REMARKS

MASAHIRO YAMANAKA
Application No.: 10/676,417
Page 8

ANNOTATED SHEET SHOWING
CHANGES

Application No.: 10/676,417

FIG. 2

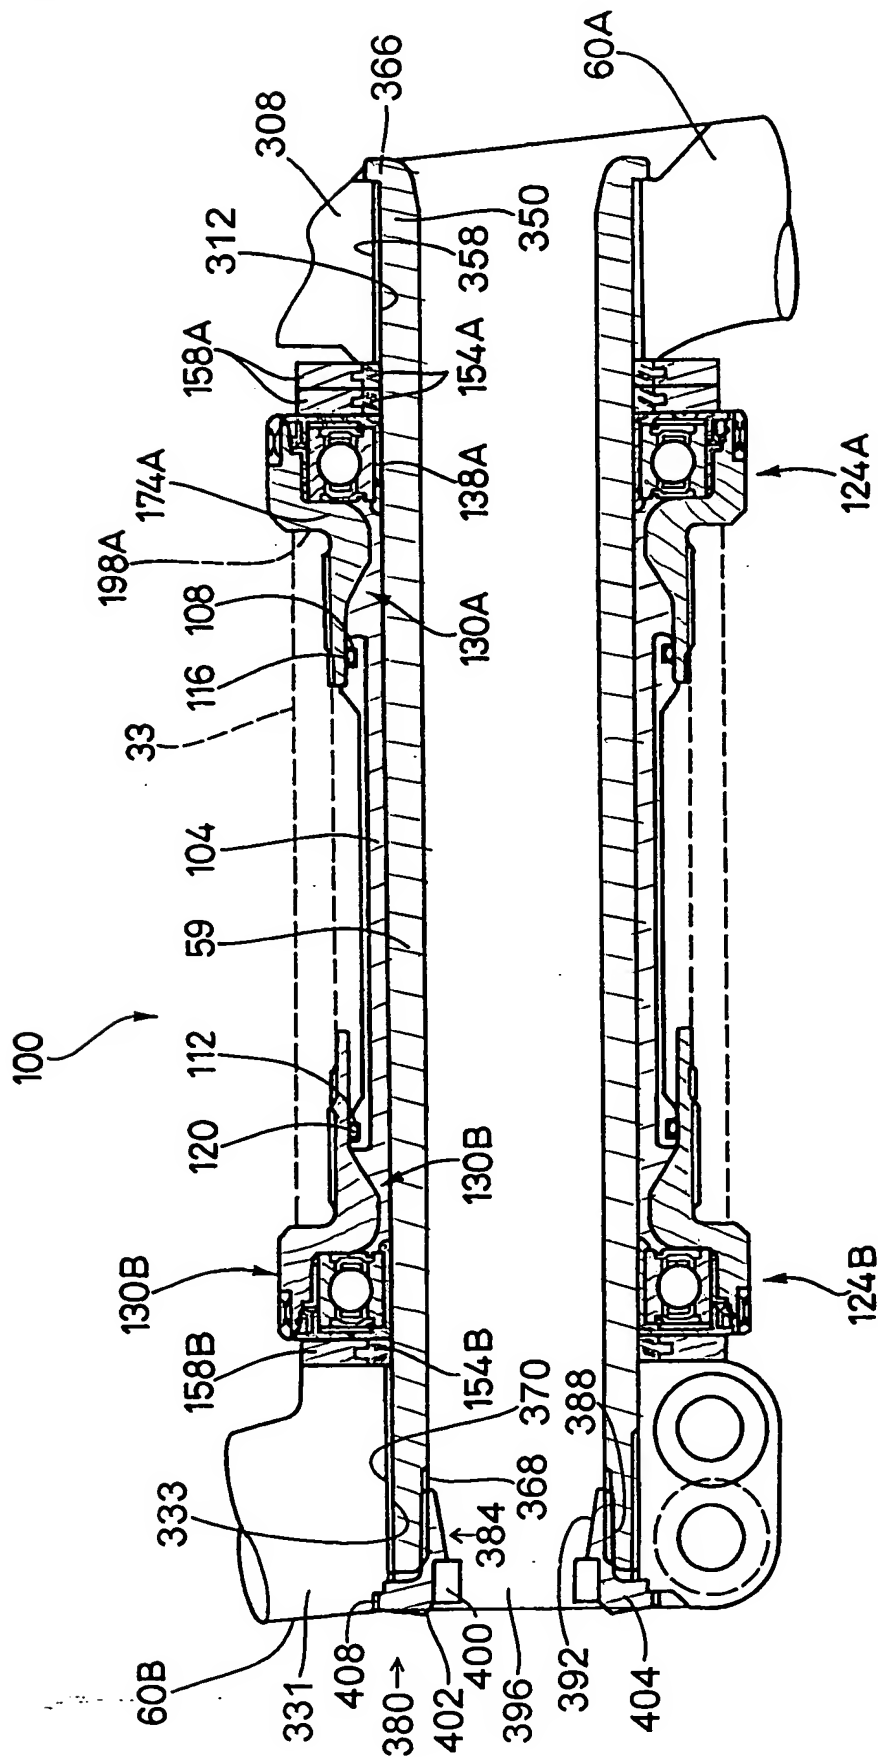
Please substitute the enclosed Figs. 2, 4 and 5 for the corresponding Figures filed on September 30, 2003. Figs. 2, 4 and 5 have been amended to add appropriate hatching for the materials therein. An annotated sheet showing the change also accompanies the replacement sheet. Both sheets are attached to the end of this paper.
